Point Beach Nuclear Plant, Units 1 and 2  
Dockets 50-266 and 50-301  
Renewed License Nos. DPR-24 and DPR-27

License Amendment Request 261  
Extended Power Uprate  
Response to Request for Additional Information

#### LICENSE AMENDMENT REQUEST 261 EXTENDED POWER UPRATE RESPONSE TO REQUEST FOR ADDITIONAL INFORMATION

## **EDG Voltage and Frequency Profiles From the EDG Transient Load Calculation**

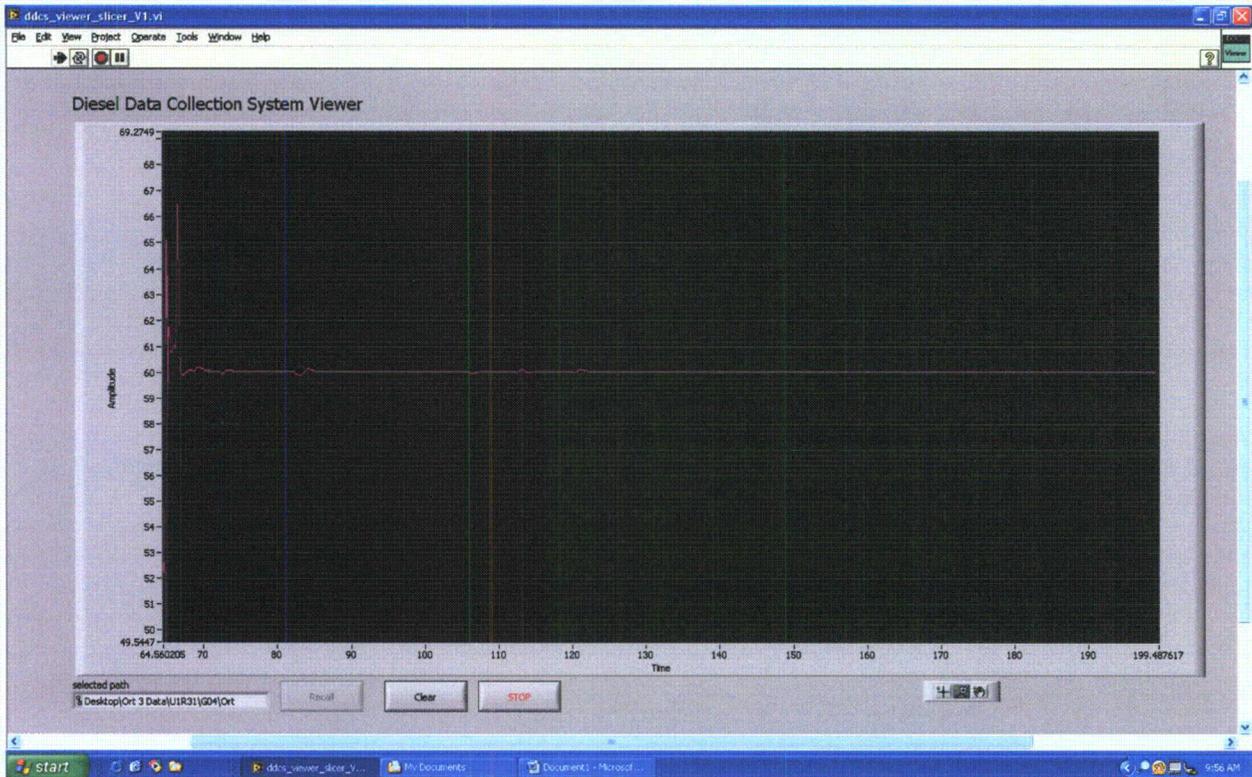
*The licensee stated that resulting worst-case calculated transient voltage dip is approximately 48 percent during the start of the motor driven auxiliary feedwater (MDAFW) pump at the time of emergency diesel generator (EDG) breaker closure. The staff notes that this voltage dip is well below the acceptance limit of 75 percent of nominal voltage during a motor start from the EDG. Please provide documentation (test data and transient analyses) to demonstrate that all loads (worst-case accident loads) can be sequenced successfully while maintaining the voltage and frequency within its design limits.*

*The licensee stated that the transient frequency response of all four EDGs remains above 57 hertz (Hz) at all times. Provide documentation to show that, during sequencing, the EDG frequency will be restored to within 2 percent of nominal in less than 60 percent of each load-sequence interval for step load increase and in less than 80 percent of each load sequence interval for disconnection of the single largest load. Also, describe how the effects of frequency variations have been evaluated to satisfy the design bases for emergency core cooling system loads and vital loads, including EDG loading.*

An engineering evaluation has been completed which demonstrates that the EDGs are capable of successfully sequencing all required electrical loads for the maximum design basis loading on the EDGs, including the loads from the upgraded auxiliary feedwater (AFW) system and alternative source term (AST) modifications. The calculation discussed above and evaluation demonstrate that the EDGs are capable of starting and accelerating all safeguards loads to rated speed within the time requirements of the accident analysis and the EDGs recover back to

nominal voltage and frequency. The calculation and evaluation show that the Train B EDGs remain above 75% of nominal voltage throughout the motor starting sequence in all cases. The Train A EDGs voltage will dip to approximately 48% of nominal voltage during the AFW pump motor start. The evaluation and calculation also show that this voltage dip will not impact the capability of the EDGs and safeguards loads from performing their specified safety function. The evaluation demonstrates that voltage recovers to acceptable levels (within  $\pm 5\%$  of 97.5% of nominal voltage) prior to a start of a subsequent motor.
